PAVEMENT FOR ACCESS ROAD
TO
NORTH VALLEY PARK

ADDENDUM
NO. 3

26 18.06 0284
ADDENDUM
NO. 3

TITLE
NORTH VALLEY PARK ACCESS ROAD PAVEMENT

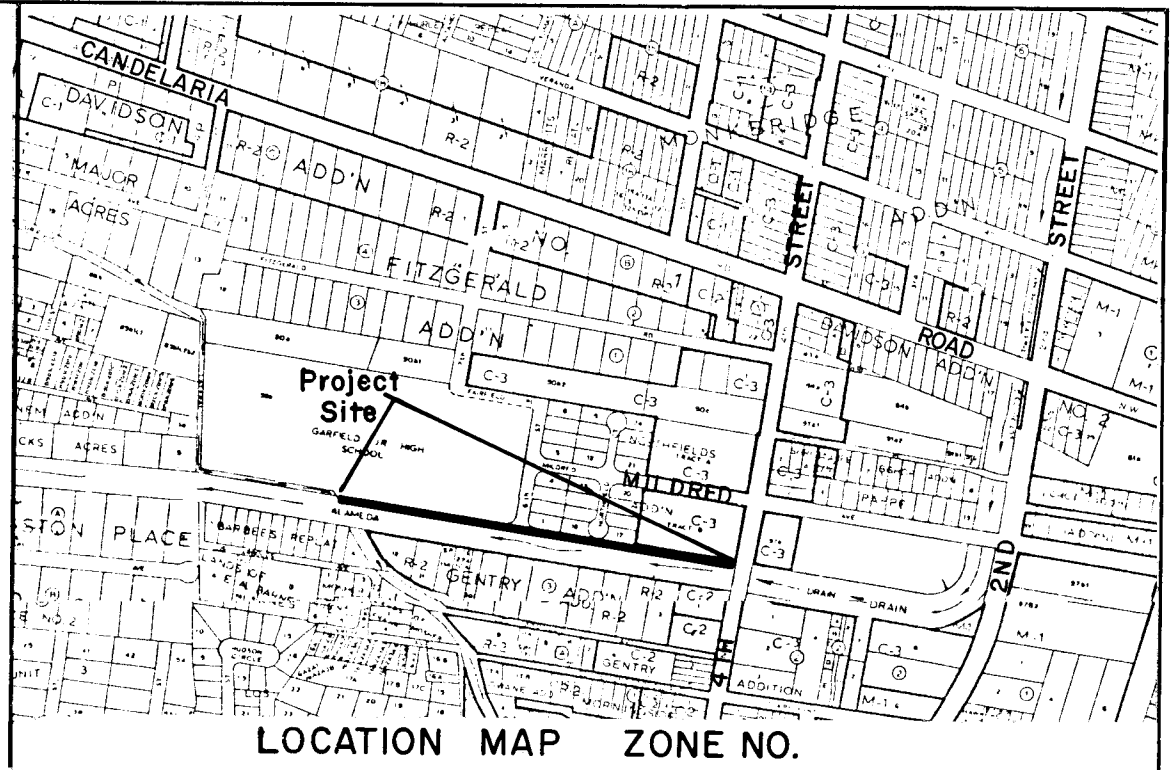
1/26/84	NOTICE TO CONTRACTORS	P. F.
2/2/84	Deleted "Block-to-Block"	C. T.
NO.	DATE	REMARKS
		BY

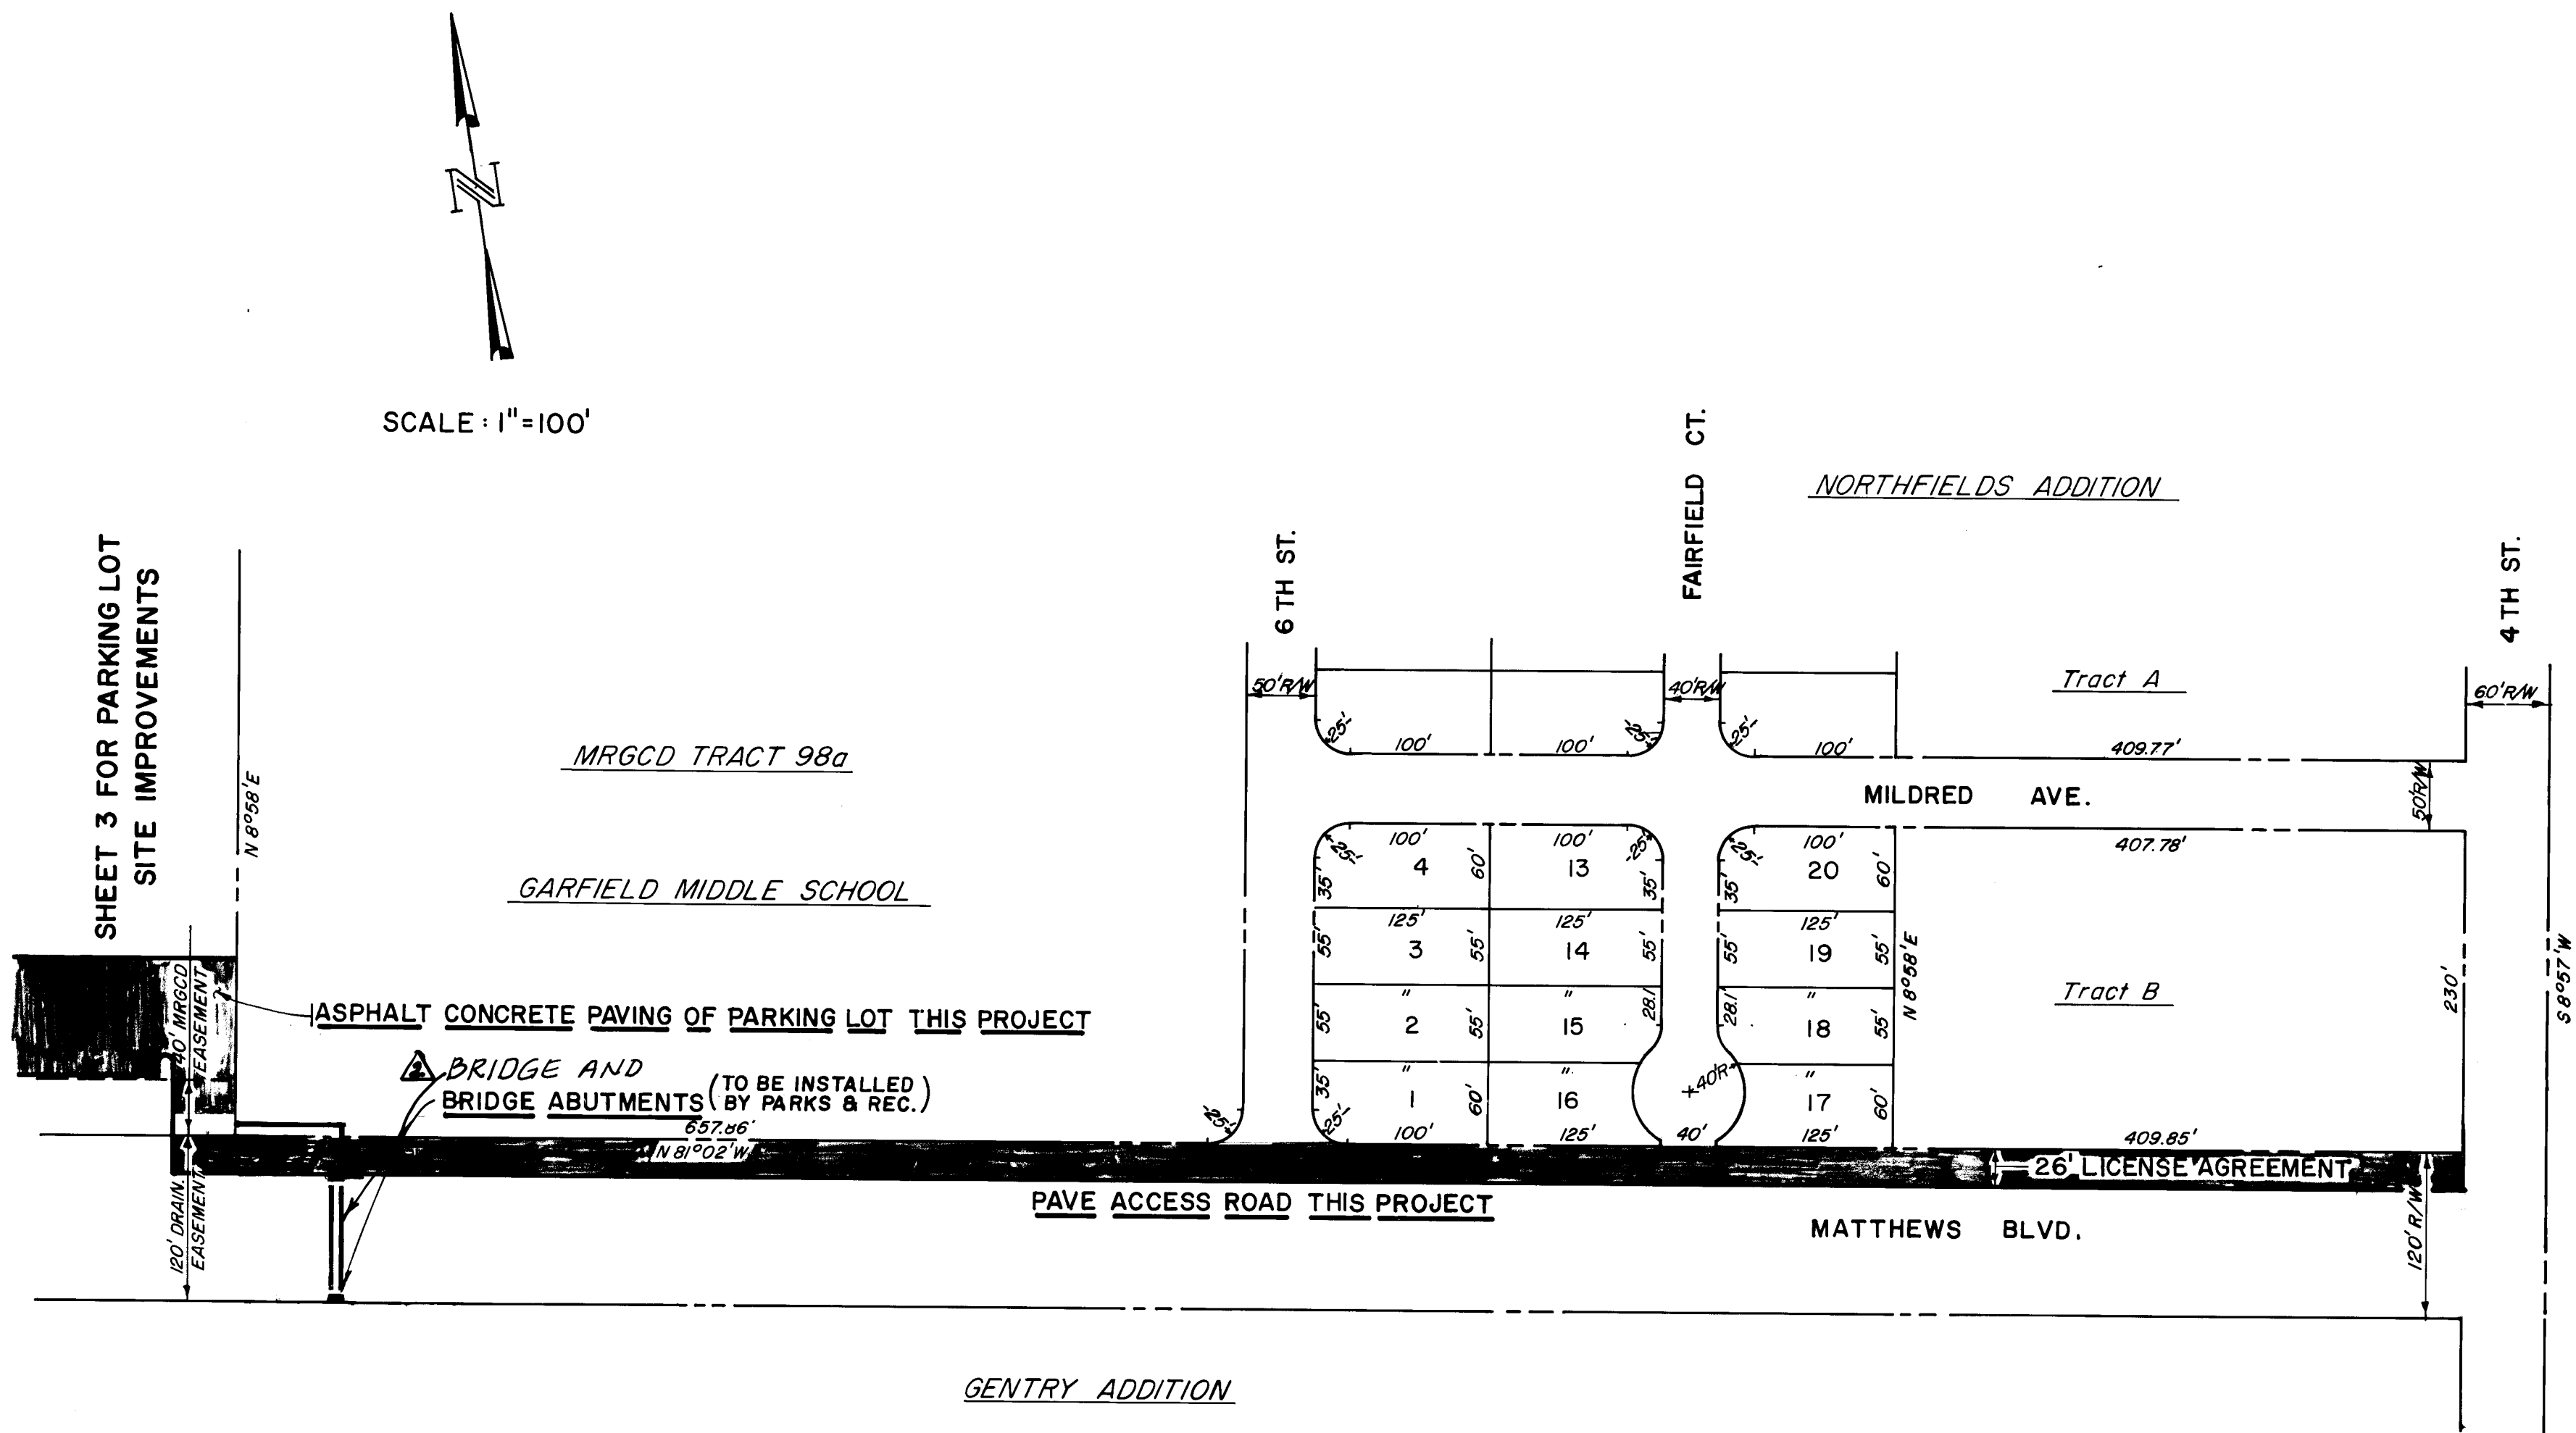
ENGINEER'S SEAL		SURVEY INFORMATION		BENCH MARKS		AS BUILT INFORMATION	
NO. DATE P-33 6-20-83 BY AQUAR DATE 6-20-83 LOCATED AT THE INTERSECTION OF 4TH & CLAREMONT N.W. IN THE SOUTHEAST QUADRANT OF THE INTERSECTION.	C.K. BY NO. DATE 2/2/84 Added "Bridge and"	NO.	BY	B. M. 5-H14	CONTRACTOR	WORK	DATE
		NO.	BY	LOCATED AT THE INTERSECTION OF 4TH & CLAREMONT N.W. IN THE SOUTHEAST QUADRANT OF THE INTERSECTION.	INSPECTED BY	INSPECTION	DATE
		NO.	BY	REVISIONS	REVISIONS	REVISIONS	DATE
		NO.	BY	DESIGN	DESIGN	DESIGN	DATE
DESIGNED BY C. TOMLINSON DRAWN BY M. J. ZAMORA CHECKED BY		MICRO-FILM INFORMATION RECORDED BY NO.		MICRO-FILM INFORMATION RECORDED BY NO.		MICRO-FILM INFORMATION RECORDED BY NO.

TITLE: **NORTH VALLEY PARK
PARKING LOT PAVEMENT PLAN**

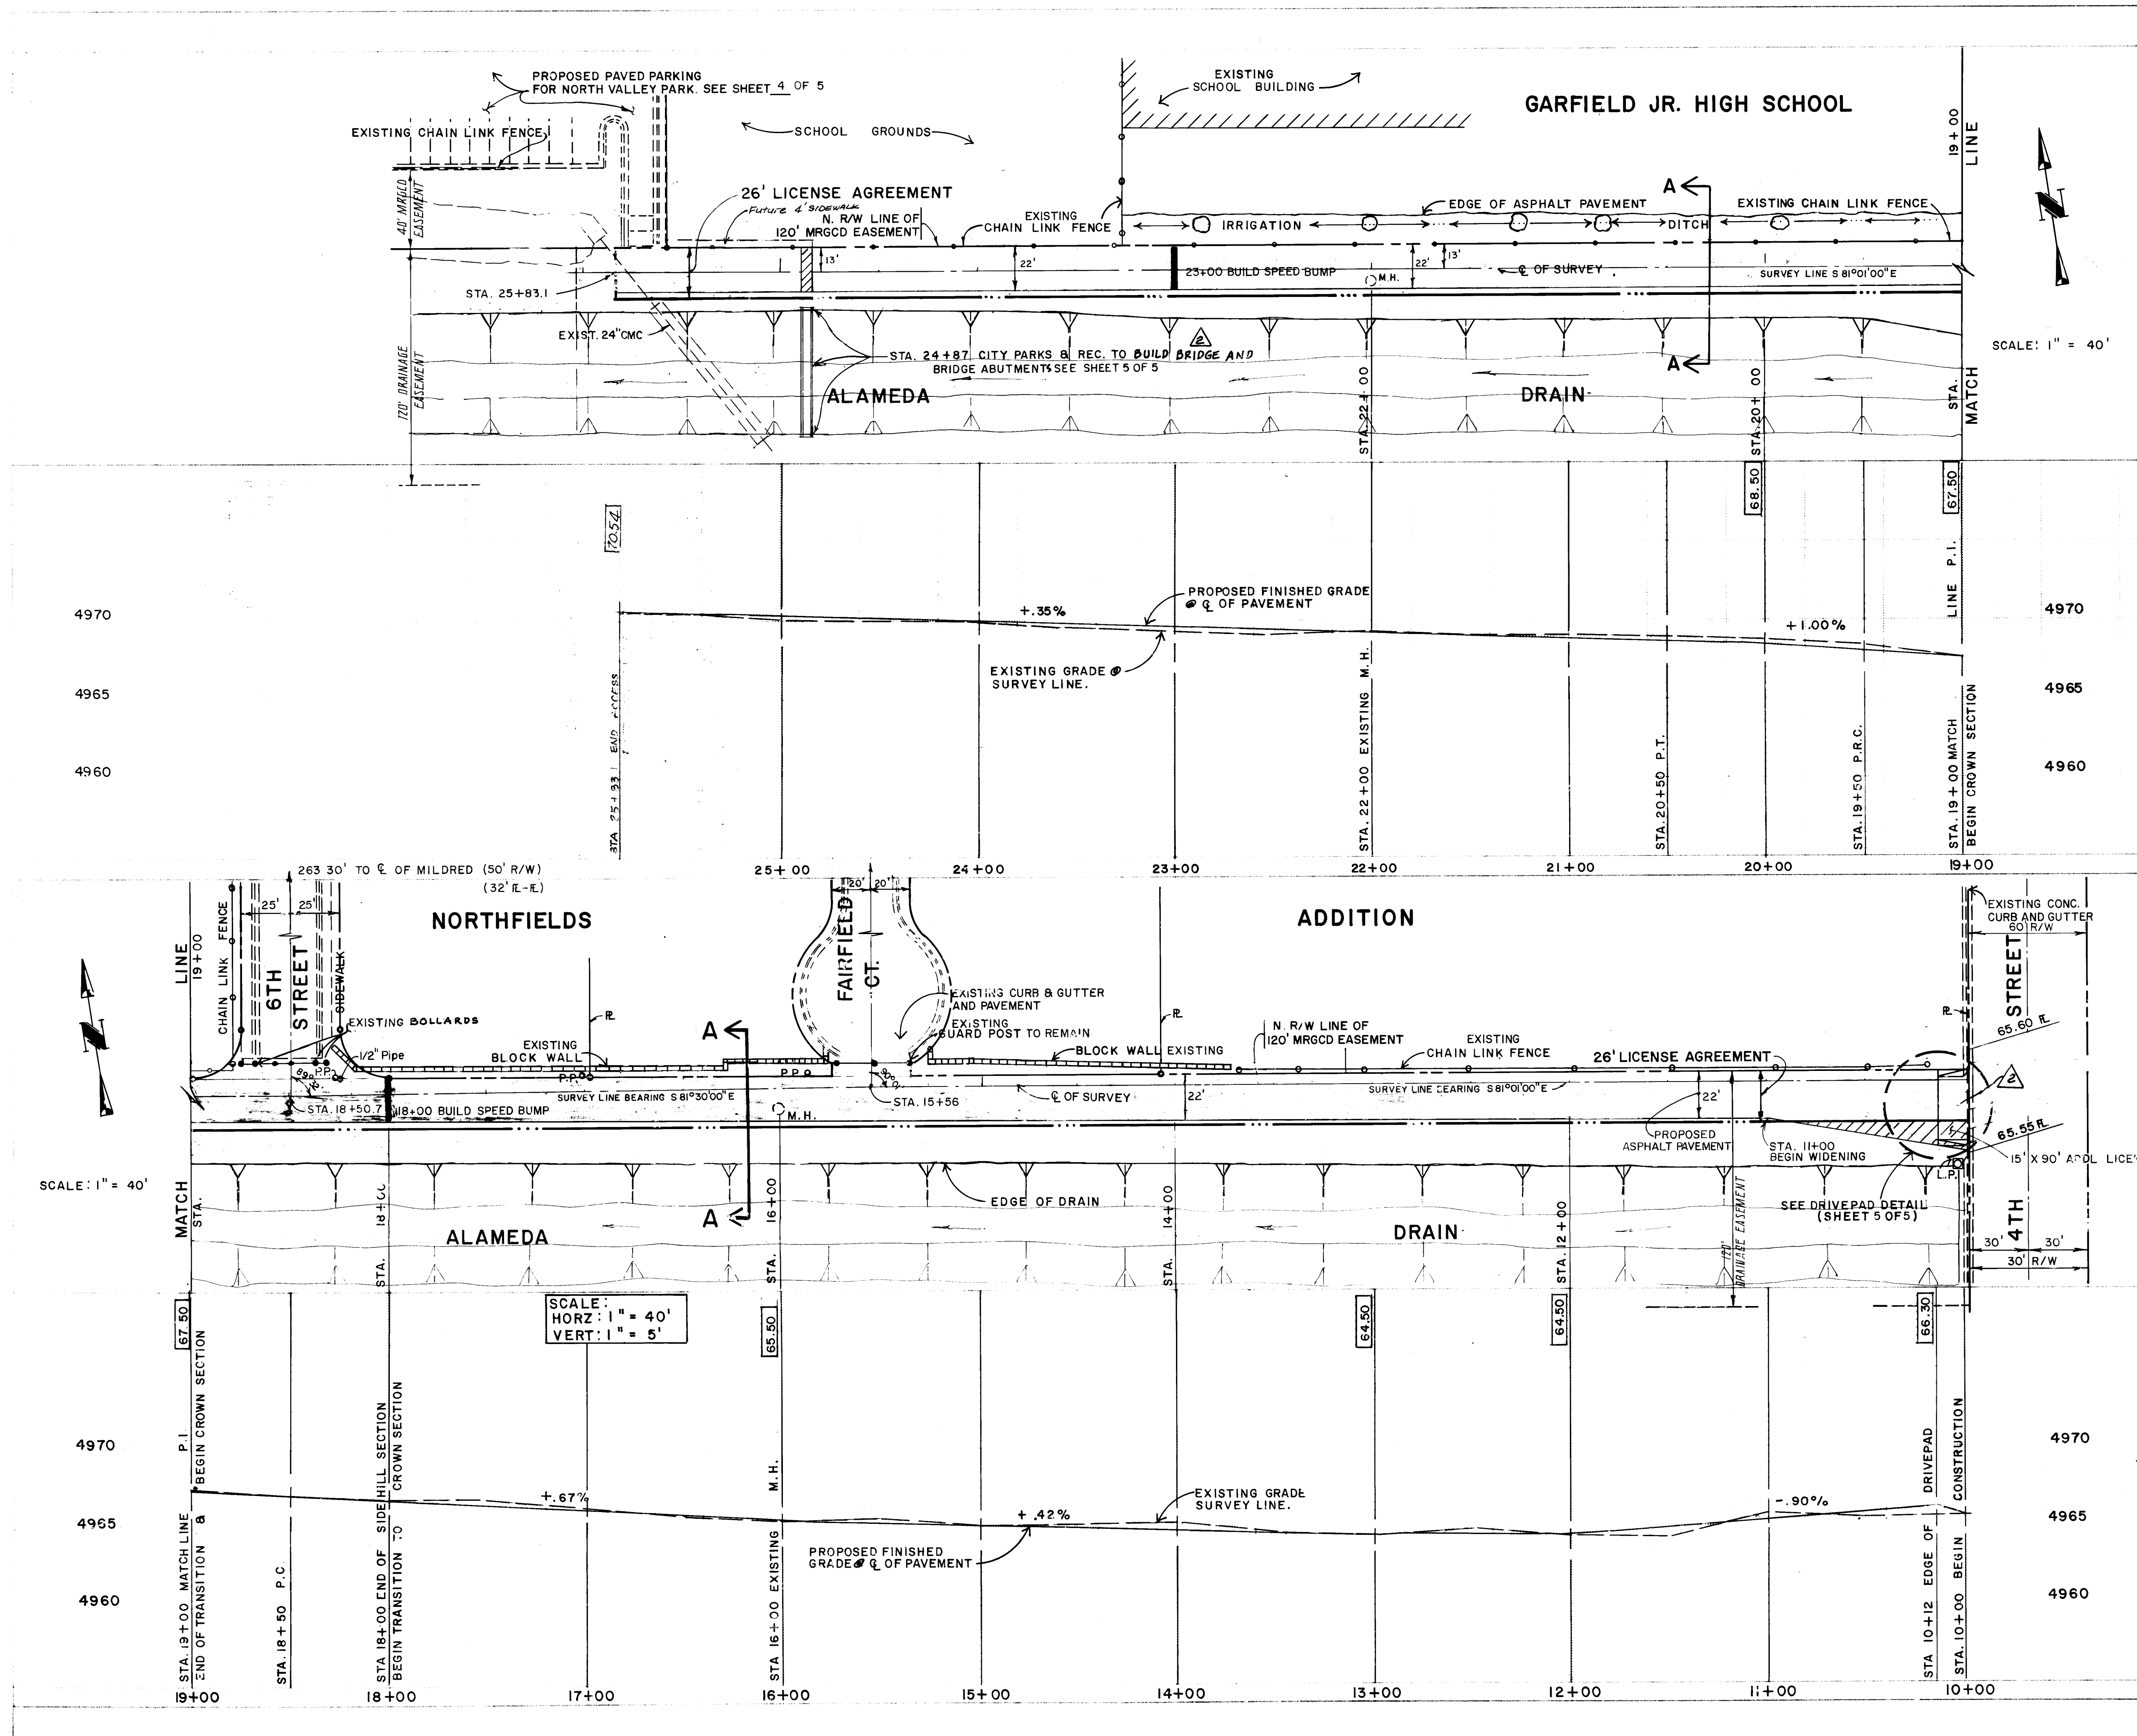
DELETED NOTE FROM ANTHONY-SEE FILE C.I. DELETED "BLOCK-TO-BLOCK" PARTS TO BUILD BRIDGE & AUTHORITY C.T.	C.T.
NO.	DATE	REMARKS							BY
DESIGN									
DESIGNED BY	DATE								
DRAWN BY M. U. ZOMORA	DATE 8 / 83								
CHECKED BY	DATE

NOTE:  THE ~~BLOCK TO BLOCK~~ CONTRACTOR SHALL PAVE THE PARKING LOT ACCORDING TO THE PROPOSED PAVEMENT SECTION.

THE CITY PARKS & RECREATION DEPARTMENT SHALL BUILD THE CONCRETE STANDARD CURB & GUTTER, SIDEWALKS AND DRIVEPAD, ~~BRIDGE~~ ^{NO ADJUSTMENTS}. INSTALLATION OF GATES FENCES AND BIKERACK, PAINTING AND STRIPING SHALL BE DONE BY PARKS DEPARTMENT ALSO.
